Contract No. HK/2009/02
Wan Chai Development Phase II – Central – Wan Chai Bypass at Wan Chai East
Further Environmental Permit – No FEP – 01/364/2009
Submission of Landscape Plan (Revision E)

Landscape plan (Rev.E) under FEP-01/364/2009 for Contract No. HK/2009/02

**Contract No HK/2009/02 Wan Chai Development II – Central- Wan Chai Bypass at Wanchai East
Landscape Plan**

DRAWING NO. SK175 (2) REV H

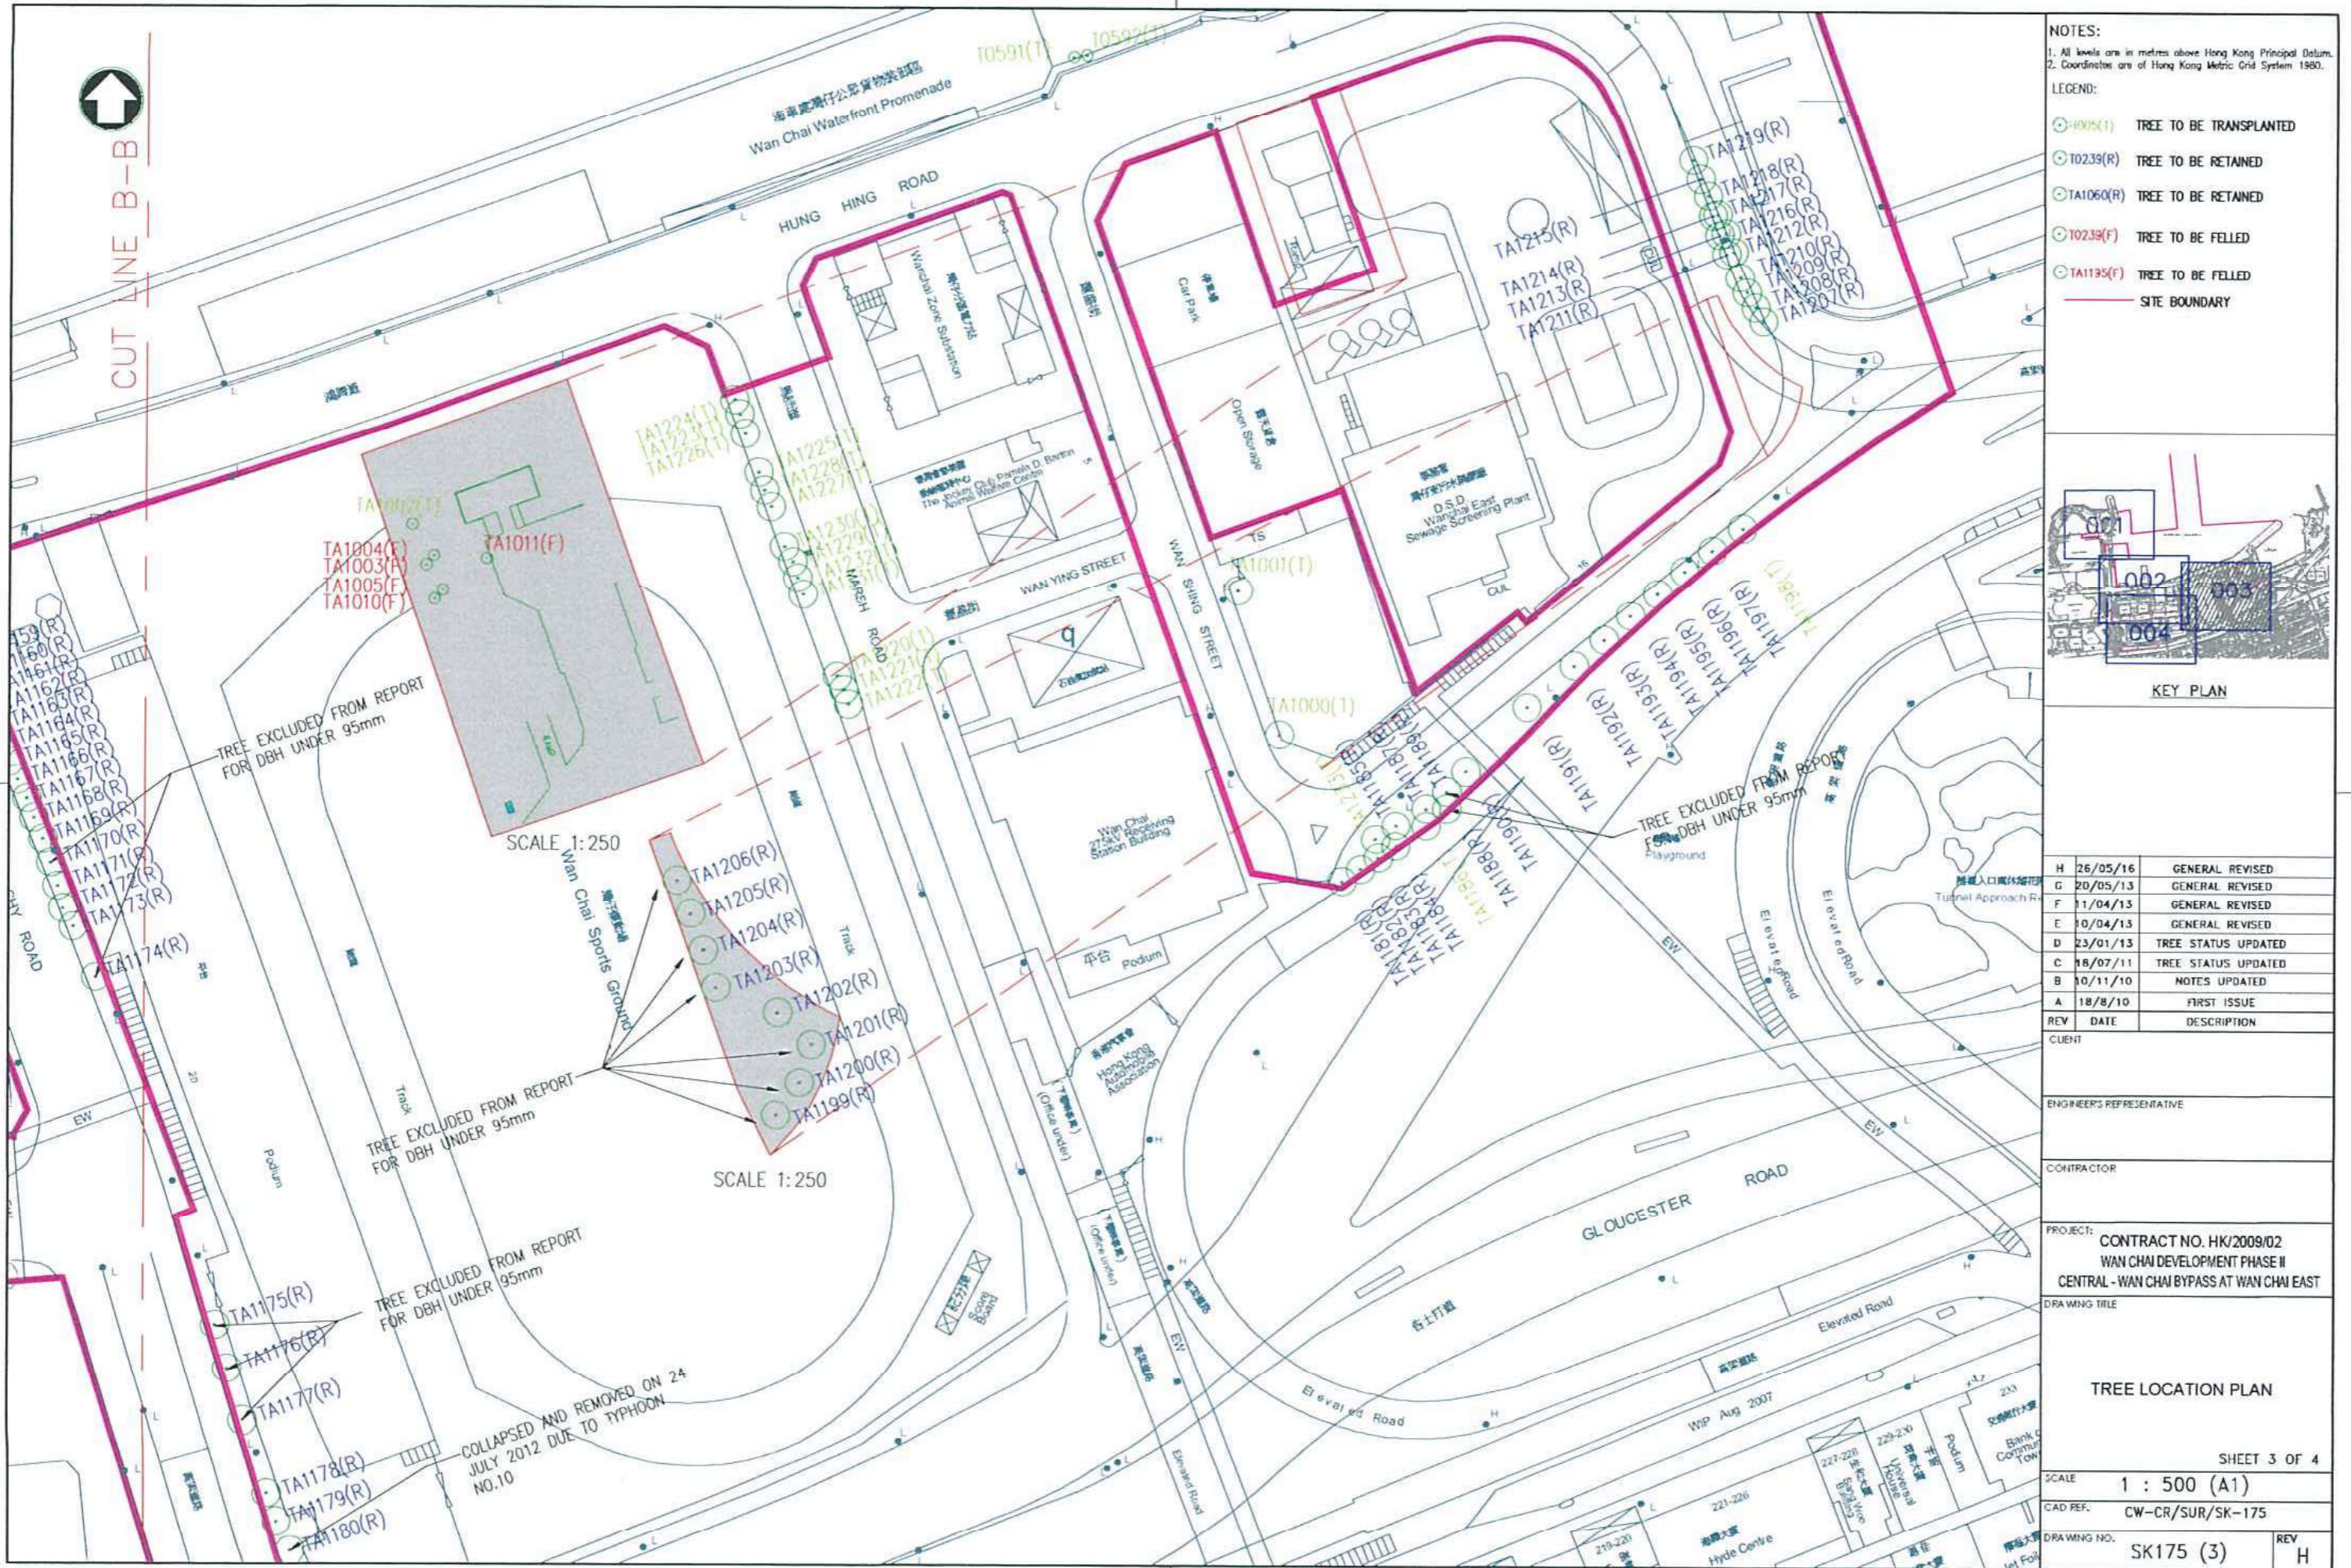
Comment	Response to Comment
<p>(5) Tree Location Plan (Drg No SK175 (2)) – It is noted that T0447 to T0452, which are originally proposed to be retained, have been removed by WDII Contract HK/2009/01. However, there is no explanation or justification for why those trees need to be removed. Details of the tree removal, such as, date, before and after photo records, reasons, etc, should be reported.</p>	<p>All the 6 trees (T447 to T452) were transplanted by another Contractor, Chun Wo - Leader JV of WDII Contract HK/2009/01.</p> <p>Separate “Updated Landscape Plan (Rev 5)” to reflect the situation was submitted by another Contractor, Chun Wo - Leader JV of WDII Contract HK/2009/01; reference: CL0907/01.03.00.00/17329/L dated 21 February 2018.</p>
<p>(6) The Tree Preservation Schedule and Summary of Protection Method should be updated to reflect the actual situation.</p>	<p>Separate “Updated Landscape Plan (Rev 5)” to reflect the situation was submitted by another Contractor, Chun Wo - Leader JV of WDII Contract HK/2009/01; reference: CL0907/01.03.00.00/17329/L dated 21 February 2018.</p>

Tree Location Plan Drg No. SK175(2) Rev. C attached to Landscape Plan Revision B (submission ref: CWCRGLJV/573/7048-2012 dated 20 November 2012) showed that 6 numbers of tree, T447 to T452, "ALREADY REMOVED BY WDII CONTRACT HK/2009/01".

Since they were at site area of Contract No. HK/2009/01 instead of Contract No. HK/2009/02, they were excluded from the Tree Location Plan Drg No. SK175(2) Rev. H attached to Landscape Plan Revision C, D, and E.

The details of the above 6 numbers of tree, T447 to T452, could be found in Contract No. HK/2009/01 Landscape Plan Revision 5 (HK/2009/01's submission ref: CL0907/01.03.00.00/17329/L dated 21 February 2018).

Tree Location Plan of T447 to T452 in Contract No. HK/2009/01 Site Area

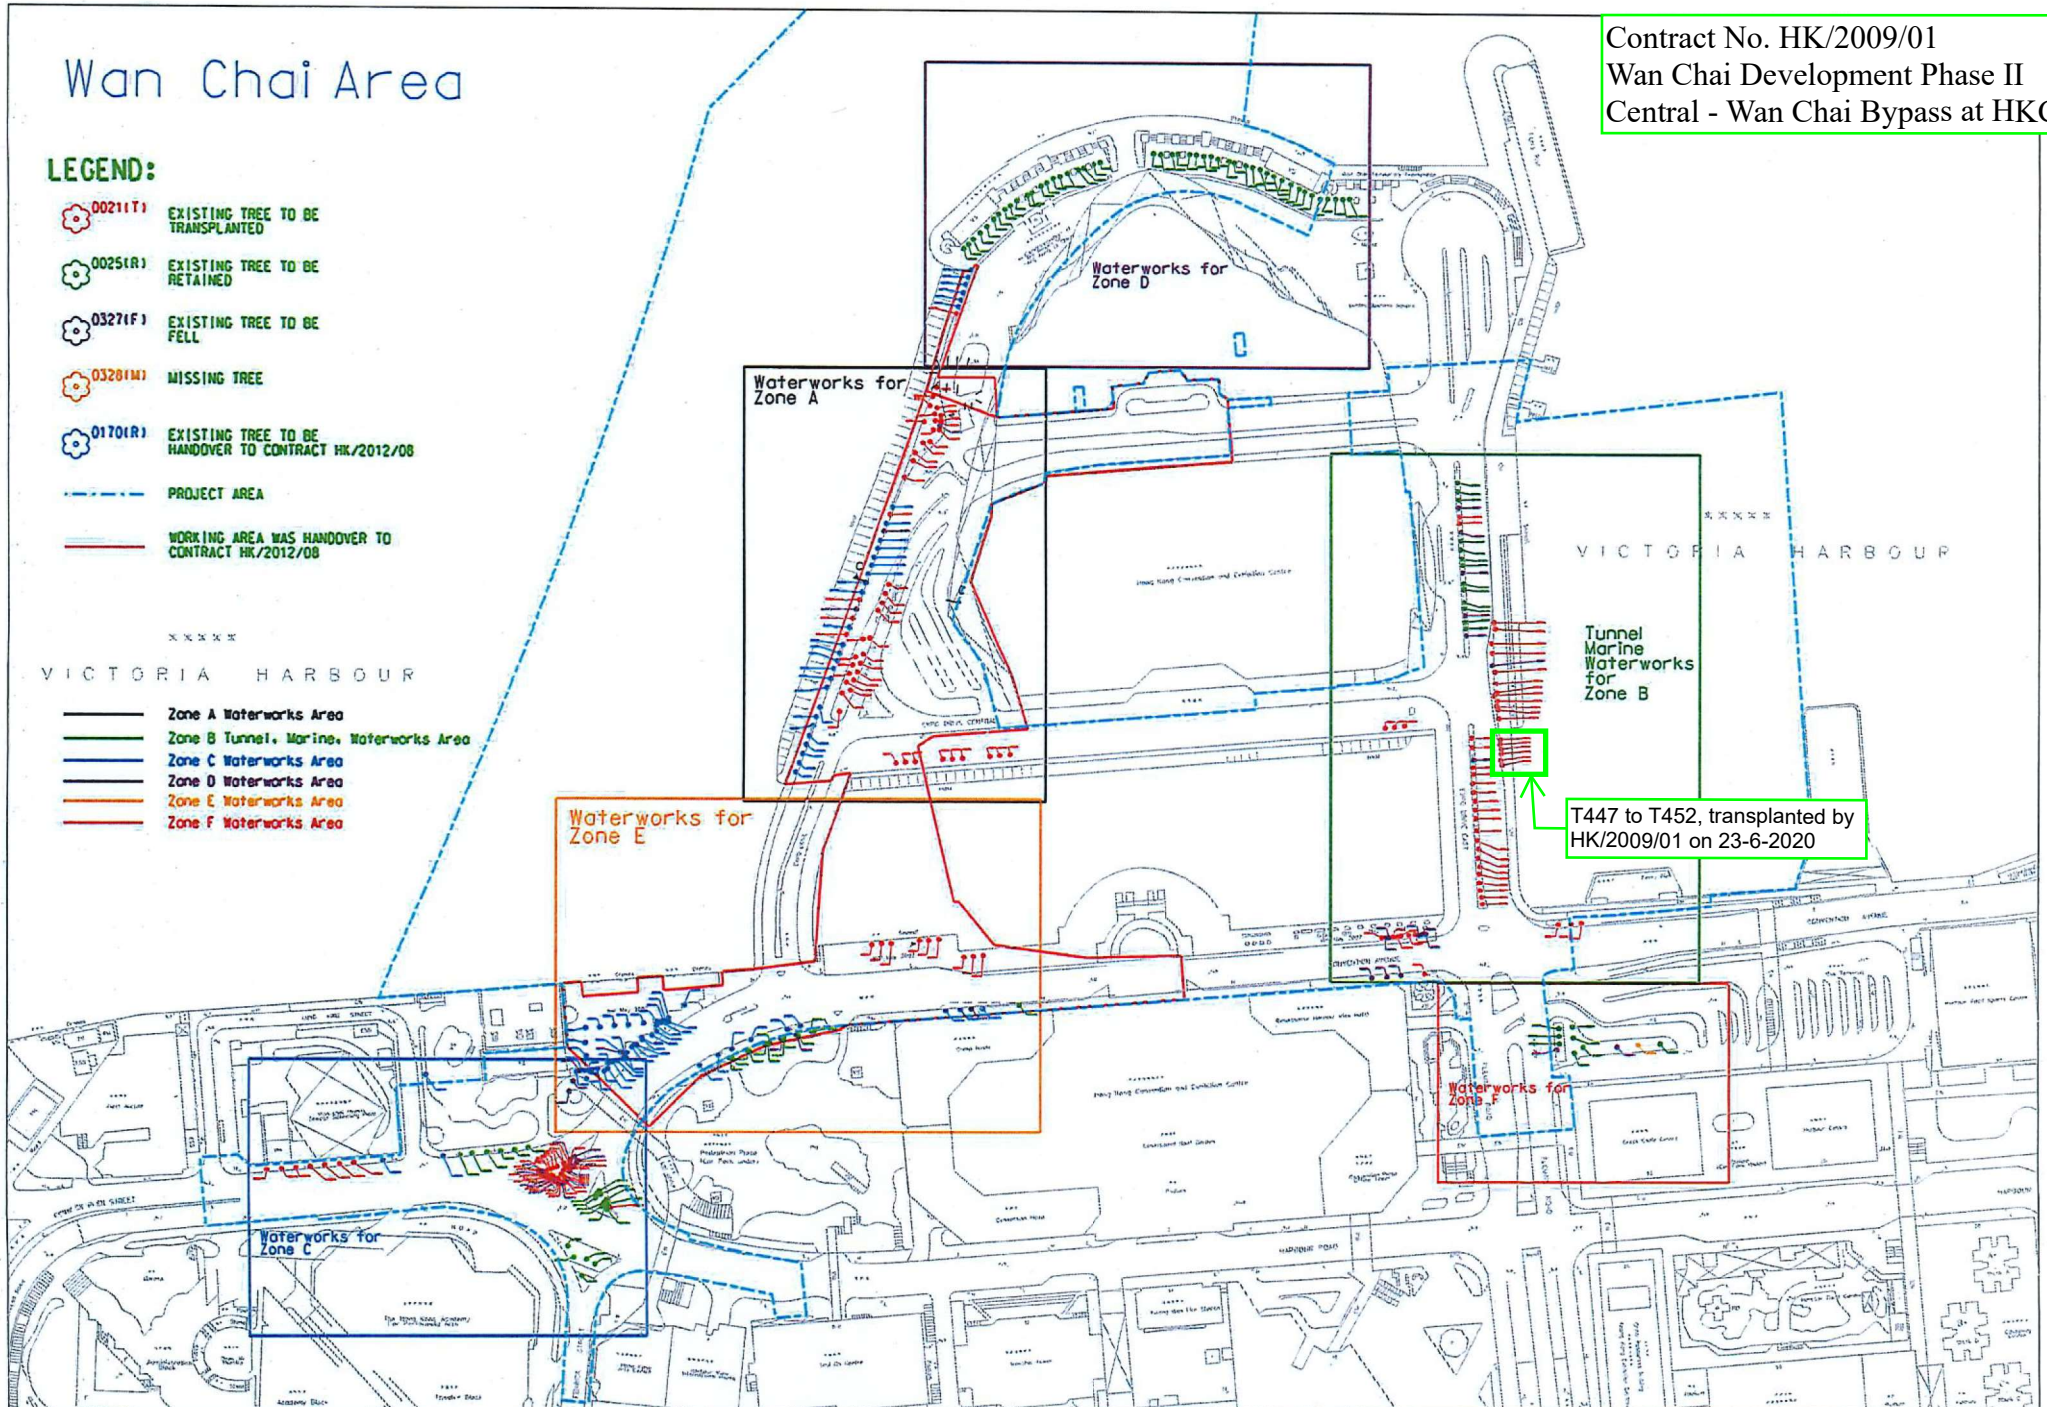
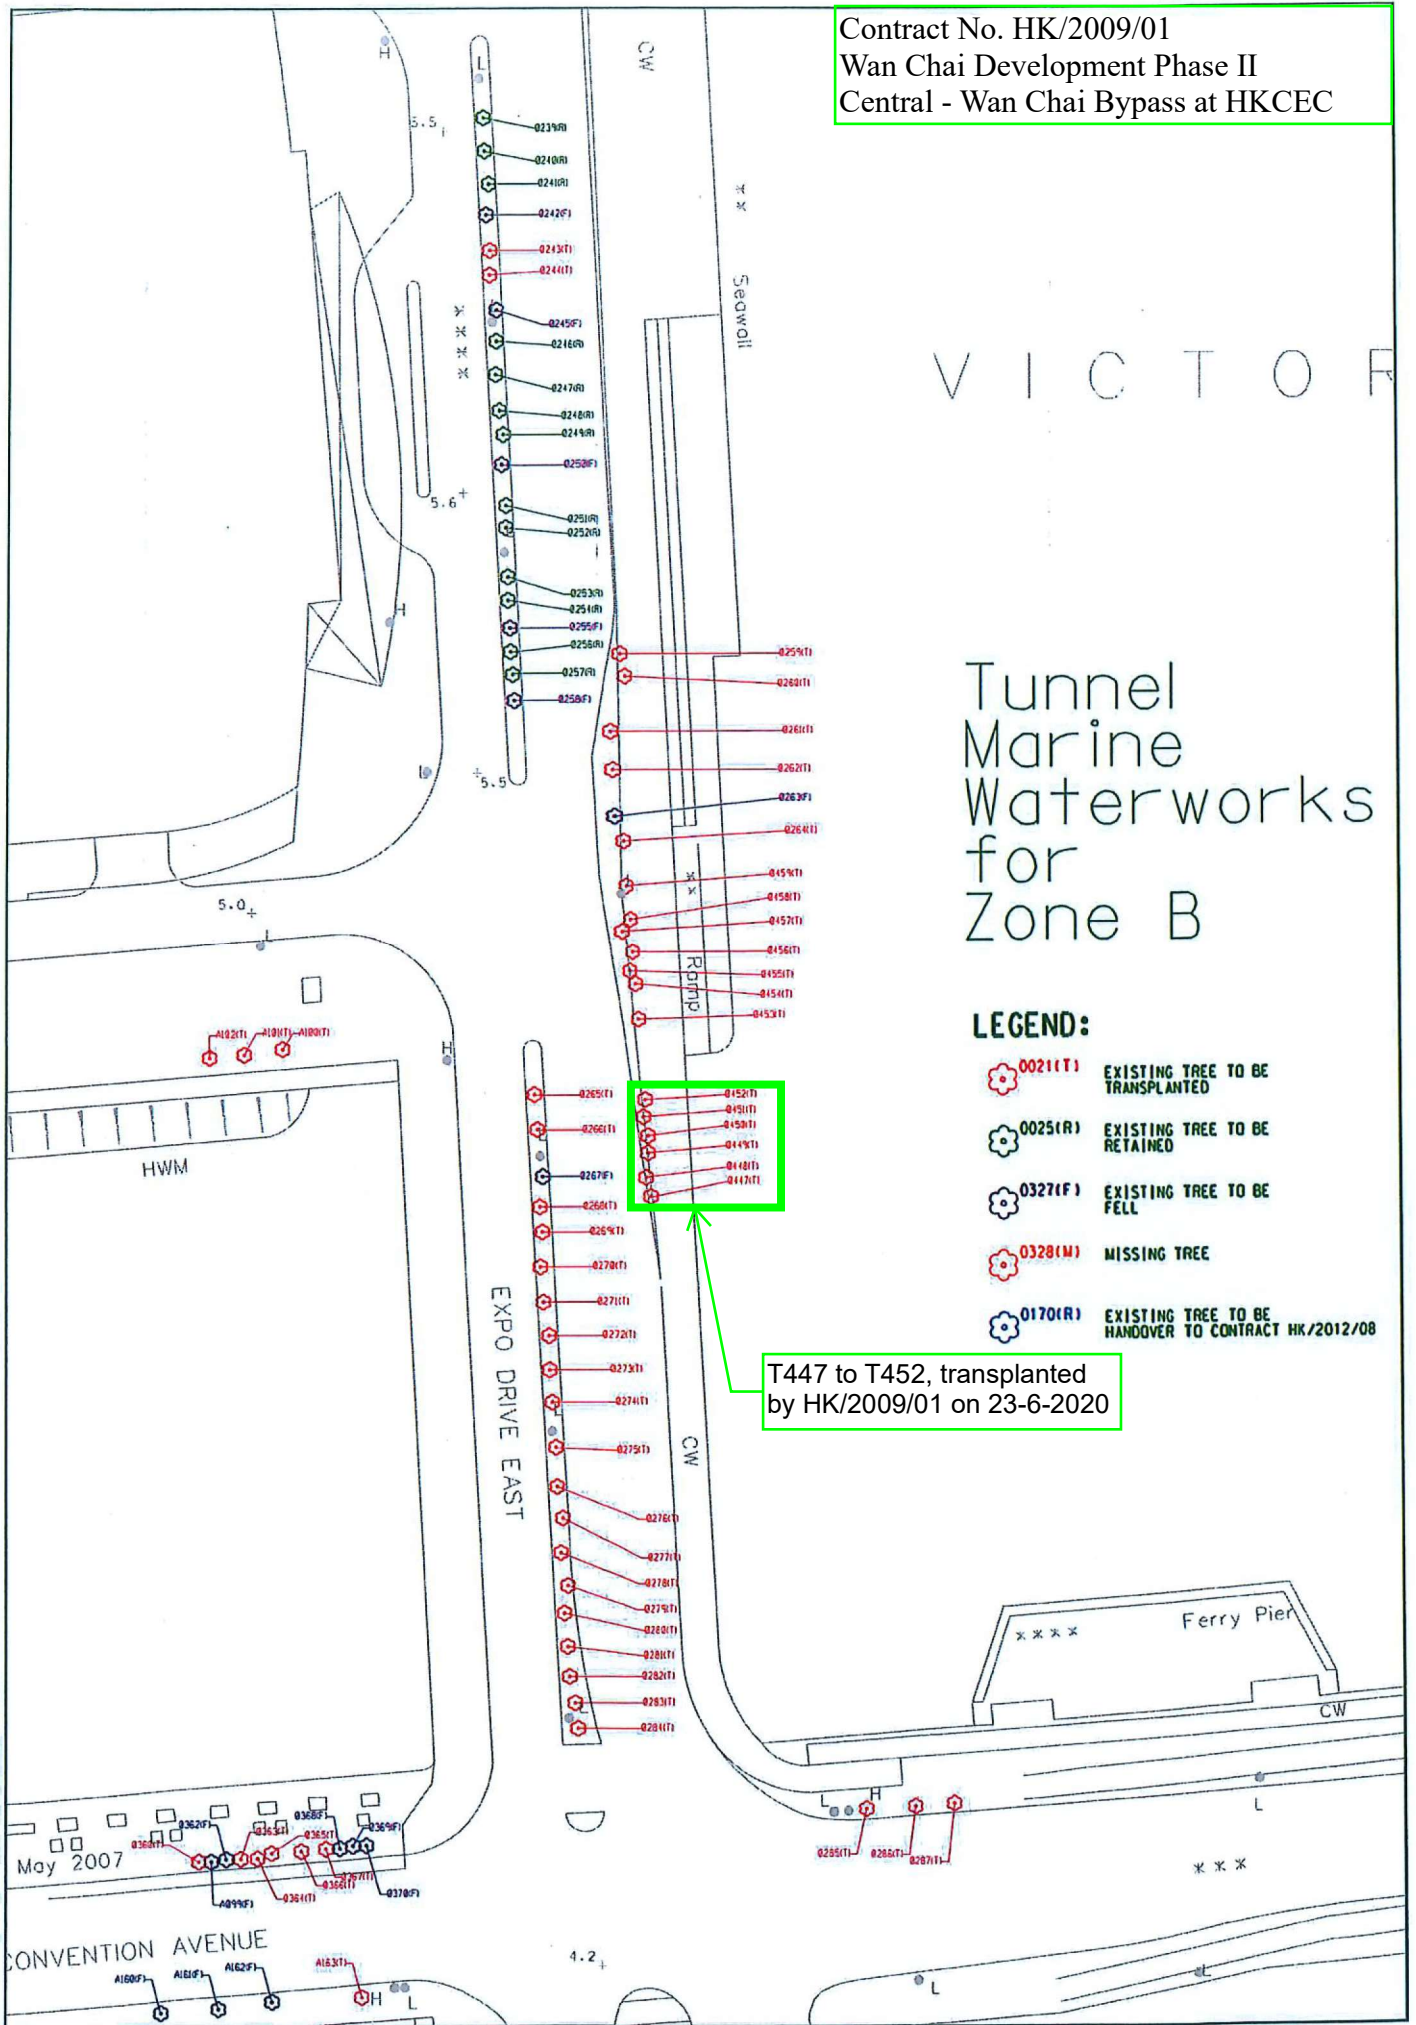
a. Item (i) of this RtoC claimed that landscape plan showing the 6 nos. of transplanted trees (T447 to T452) had been included; however, such information is not found in this submission, and list out relevant drawing no(s). for proper record. The project proponent should be reminded to include such drawing(s) in this submission, and list out the relevant drawing no(s). for proper record. In addition to the above, please ensure all drawings are in legible quality and appropriate scale as some drawings under this submission are illegible.	The location plan of the 6 nos. of transplanted trees (T447 to T452) is attached in Appendix C2.
Landscape Plan (Revision C)	
(EPD Letter Ref. No. () in EP2/H4/S3/15 Pt.57 dated 18 Feb 2021)	
I refer to your letter dated 11 January 2021 depositing this office with the captioned EP submission. Having reviewed, we have the following comments on the plan:

i. Referred to the provided Response-to-Comment Table, it is reported that the 6 trees (T447 to T452) were transplanted to	Noted and the Updated Landscape Plan (Rev 5), submitted by another Contractor, Chun Wo - Leader JV of WDII Contract HK/2009/01, Ref:

[Extracted from Contract No. HK/2009/01 Landscape Plan Revision 5 [HK/2009/01 submission ref: CL0907/01.03.00.00/17329/L dated 21 February 2018]

T447 to T452, transplanted by
 HK/2009/01 on 23-6-2020

T447 to T452, transplanted by HK/2009/01 on 23-6-2020
